Application for Licence Amendment

Licence Number	L5206/1987/10
Licence Holder	Wiluna Operations Pty Ltd
ACN	166 954 525
File Number	2012/006906-1~2
Premises	Wiluna Mine Site WILUNA WA 6646 Mining tenements M53/30, M53/32, M53/468, L53/62, L53/20, M53/64 and part tenements M53/40, M53/44, M53/50, M53/26, M53/6, M53/95, M53/96, M53/200, M53/69 and M53/24
Date of Report	06 August 2020
Proposed Decision	Revised licence granted

Figure 1: Diagram of the stage 1A embankment, from Design Report (Golder 2019)

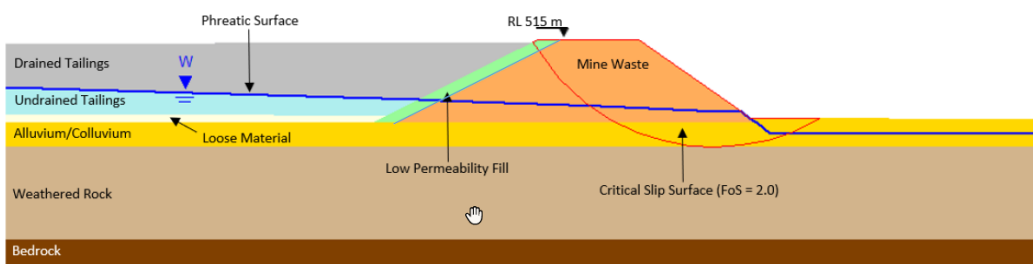
Seepage from TSF K is expected to be predominantly through the base. Seepage through the embankment is primarily controlled by the low permeability layer on the upstream slope of the TSF as shown in Figure 1, so the reduced embankment width is not expected to significantly increase the rate of seepage. The Delegated Officer therefore considers that construction of stage 1A is sufficient to commence tailings deposition, prior to the construction of stage 1B.

- Embankment height was reduced from RL515 to RL512 to prevent delays in commissioning, resulting in a corresponding reduction in capacity.
- The stage 1A embankment was constructed wider than designed, for operational reasons.
- The stage 1B buttress has not yet been constructed, as discussed above.
- There is a slight variation in pipeline placement to divert around the proposed Sulphide Processing Plant site.

The Delegated Officer is satisfied that aside from delayed construction of stage 1B (discussed above), the variations do not increase, and may decrease, the environmental risk presented from TSF K. Conditions 1, 2, 3 and 4 of W6248/2019/1 are considered to be met with respect to stage 1A.
